TITLE: SDP-01-007

Public Hearing for Schematic Development Plan SDP-01-007 for Kentlands Retail Section 2.

SUBJECT: SDP-01-007 - Archstone Kentlands Village

SCHEMATIC DEVELOPMENT PLAN
ARCHSTONE KENTLANDS VILLAGE
BLOCK Q, PARCEL H, I
PLAT No. 124 PLAT No. 19466 & PLAT No. 19469

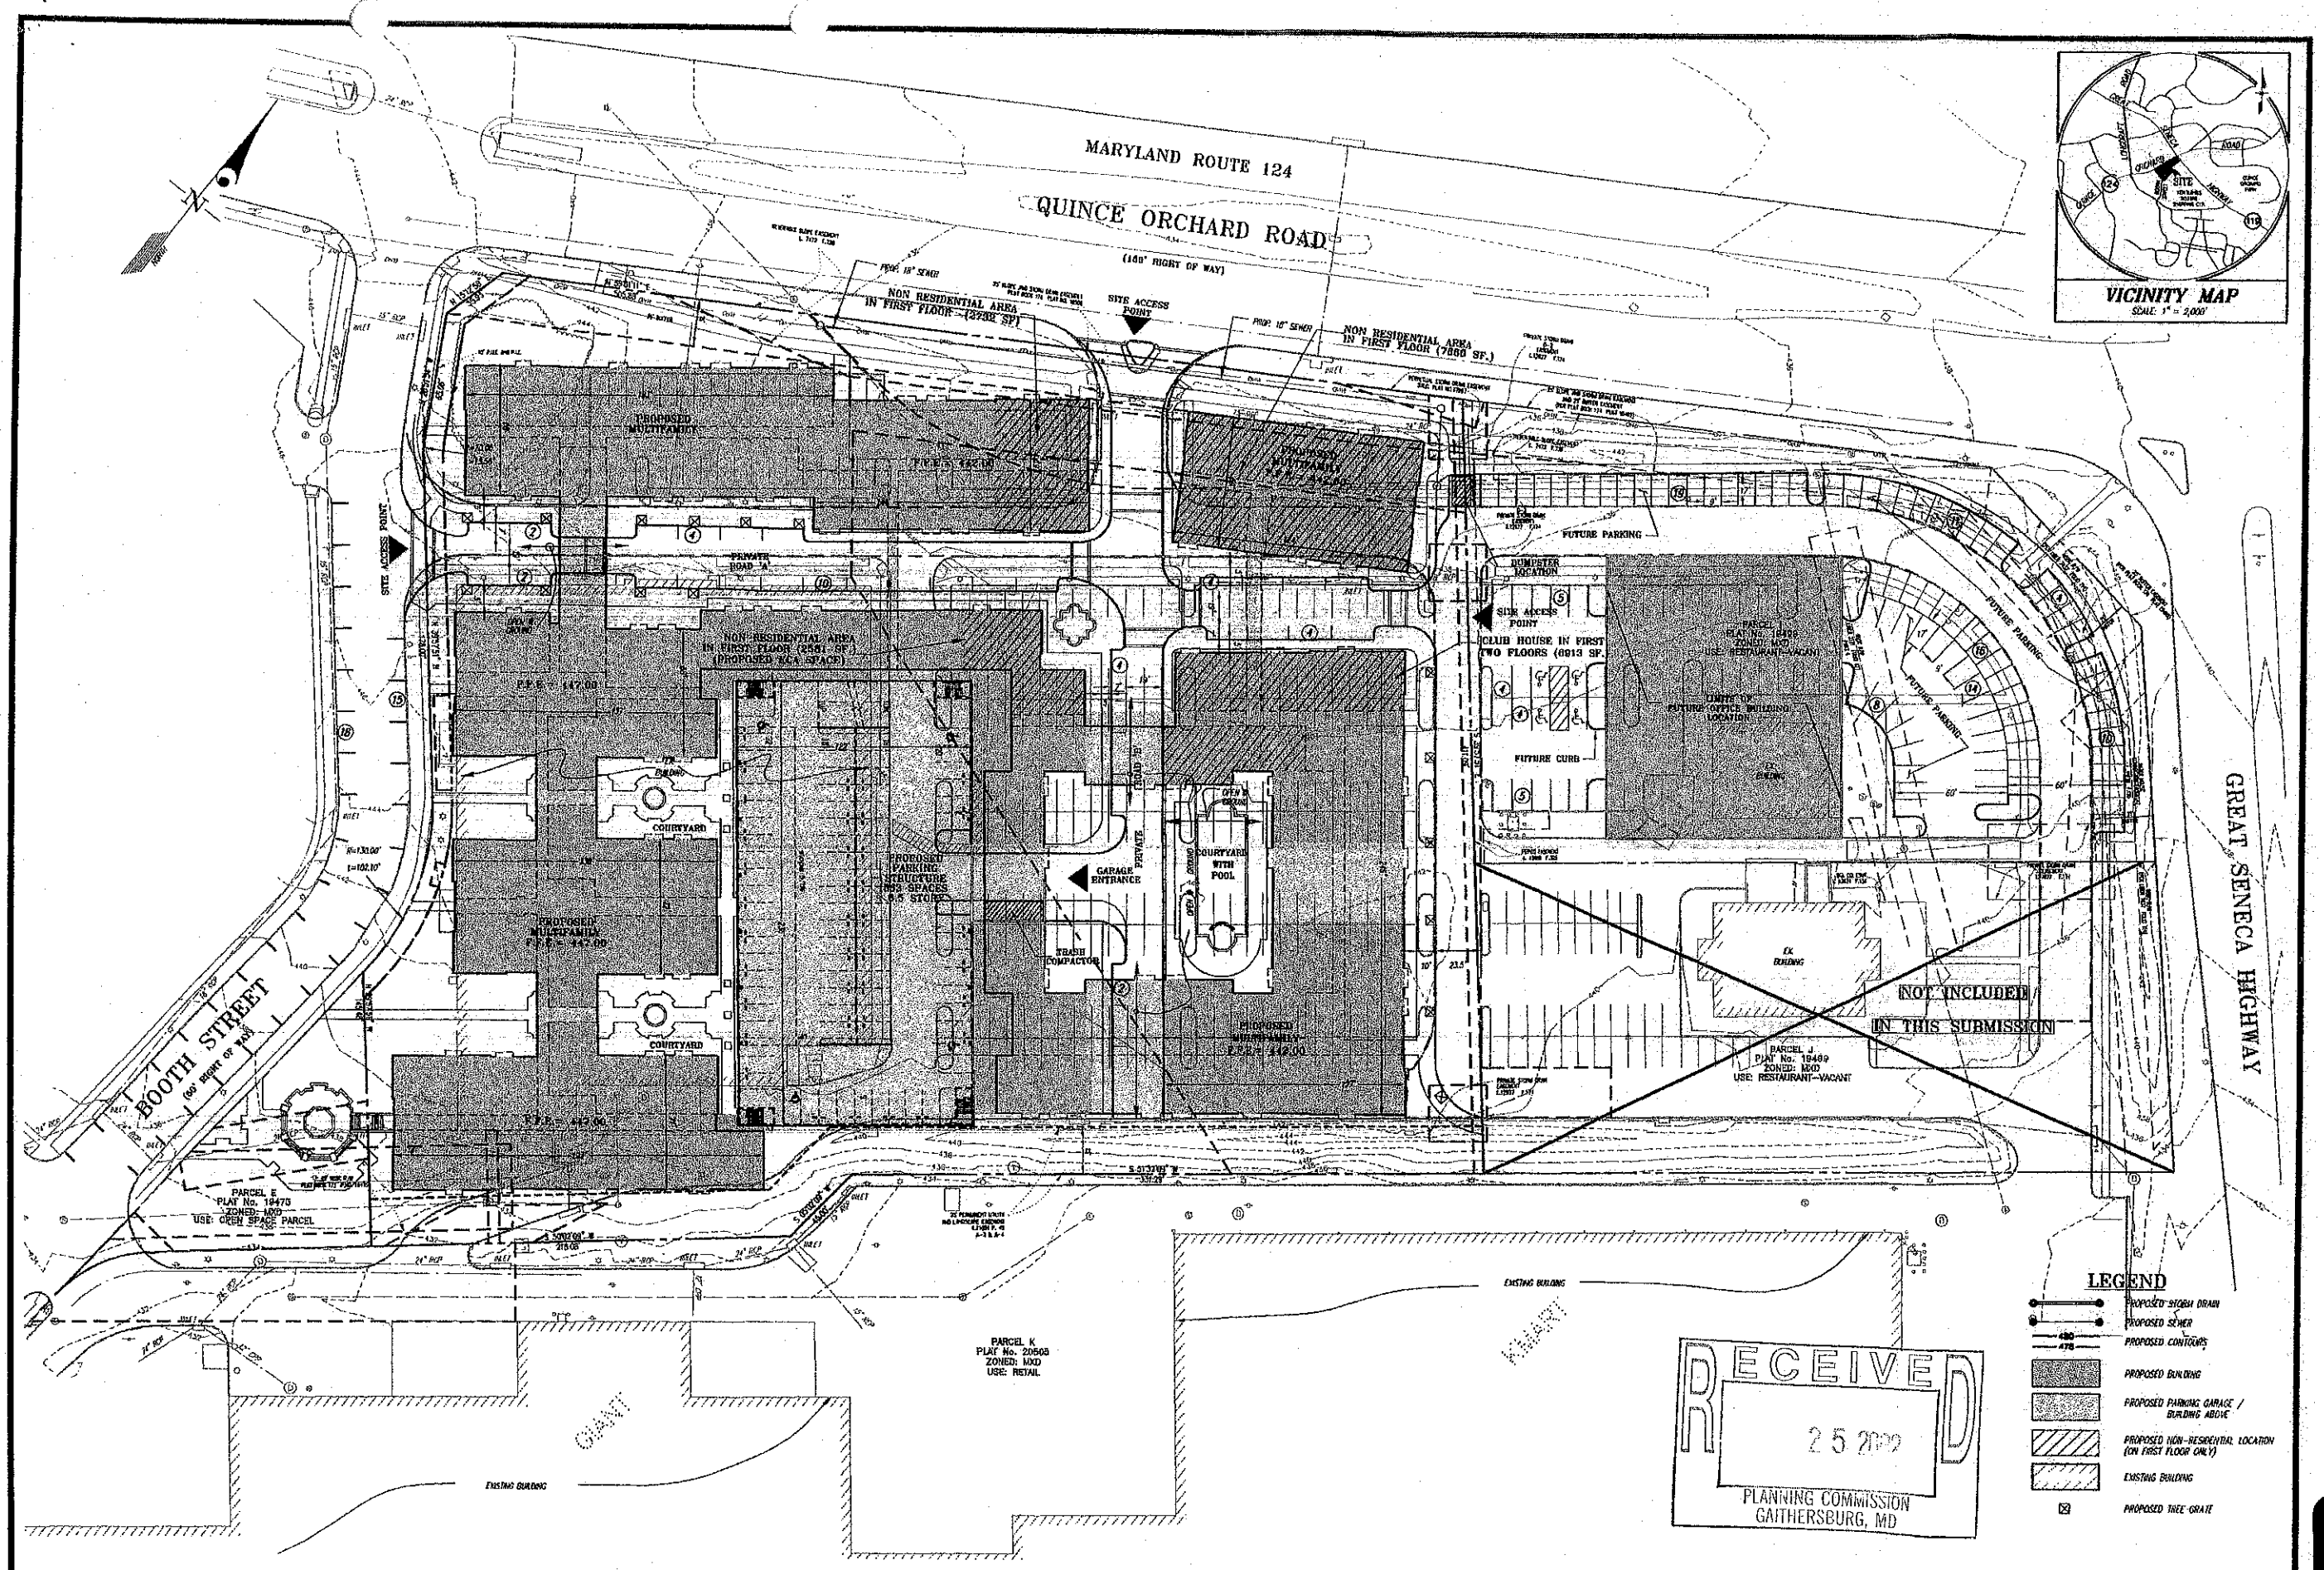
6. The final design, location and square footage of the future proposed office building, within the shaded area shown on the schematic development plan application, will be determined during the final site plan stage for the office building.

9. Provide a solution to the offset intersection of Private Road 'A' and 'B' such as a traffic circle or re-alignment. Other solutions could be in the form of modifications to the current intersection design.

6. The final design, location and square footage of the future proposed office building, within the shaded area shown on the schematic development plan application, will be determined during the final site plan stage for the office building.

10. Provide a solution to the offset intersection of Private Road 'A' and 'B' such as a traffic circle or re-alignment. Other solutions could be in the form of modifications to the current intersection design.

ELEVATIONS AT 1"=40'-0"

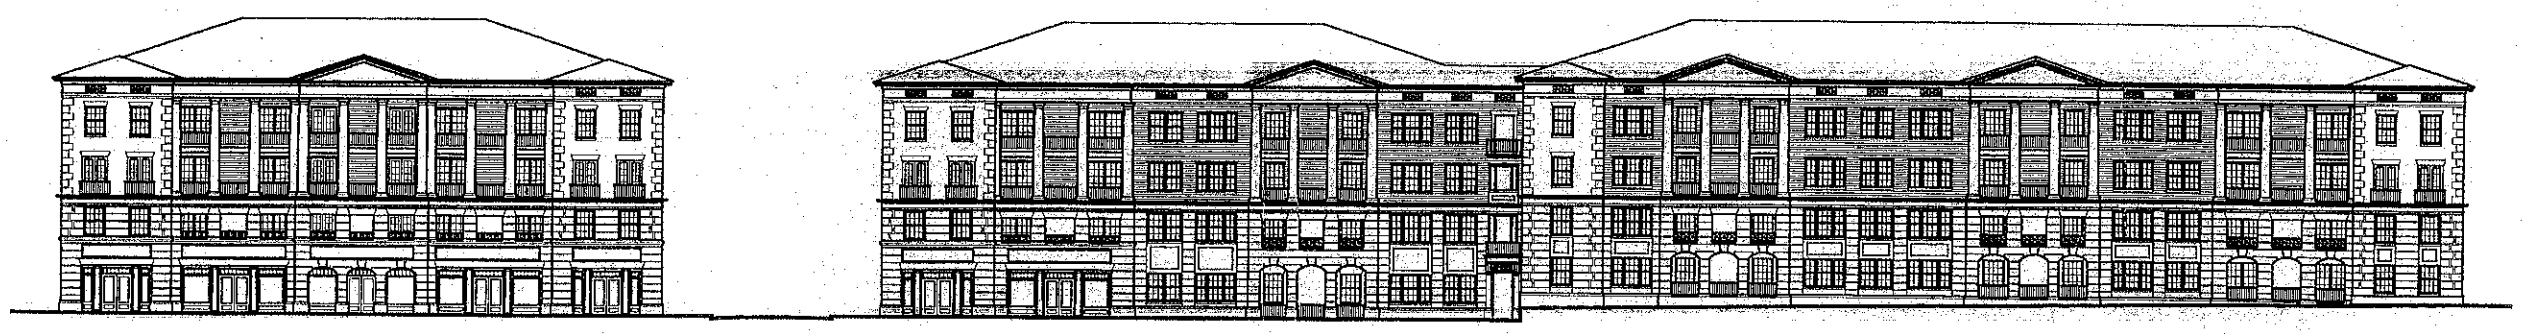
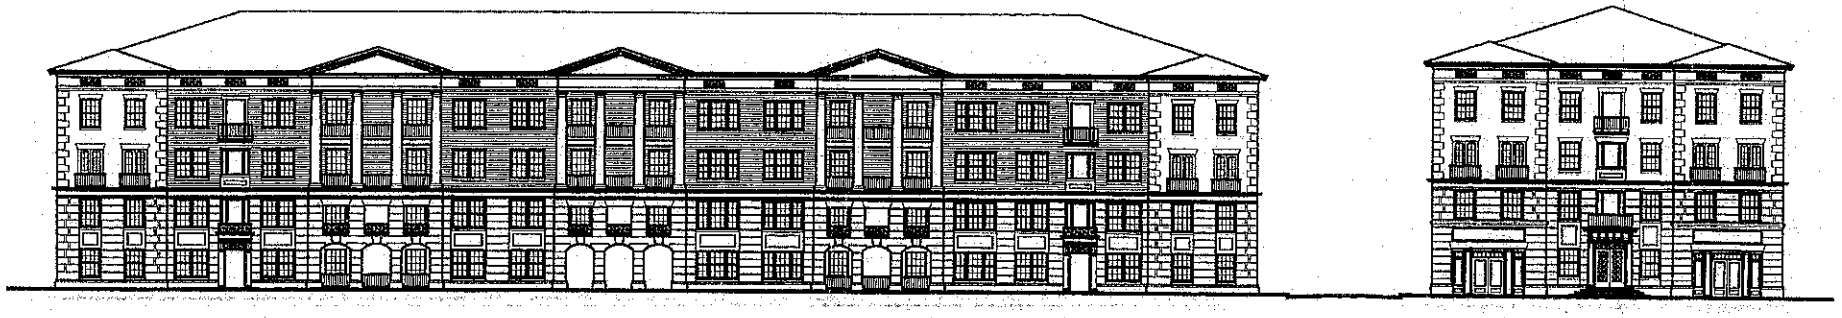
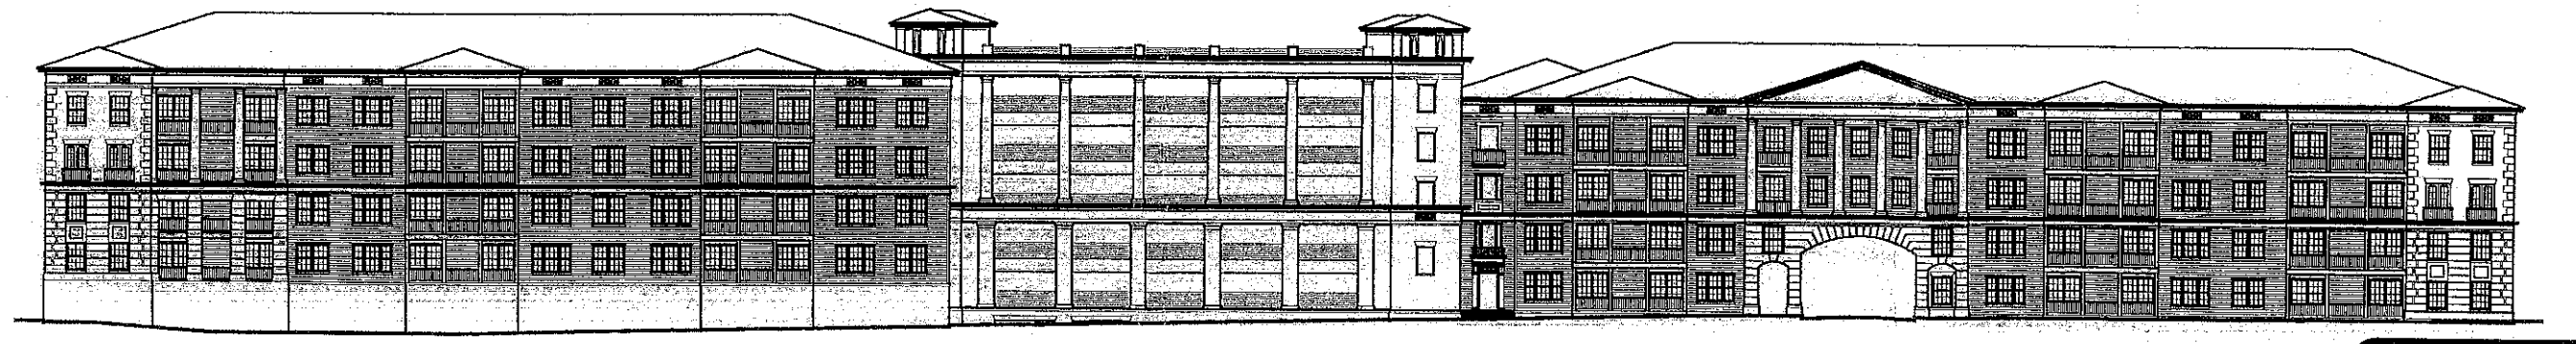
3. The final architectural elevations should be substantially consistent with or improved from the proposed elevations of the Schematic Development Plan and improved. The final architectural elevations should be reviewed and approved during the final site plan process.

3. The final architectural elevations should be substantially consistent with or improved from the proposed elevations of the Schematic Development Plan. The final architectural elevations should be reviewed and approved by the Planning Commission during the final site plan process.
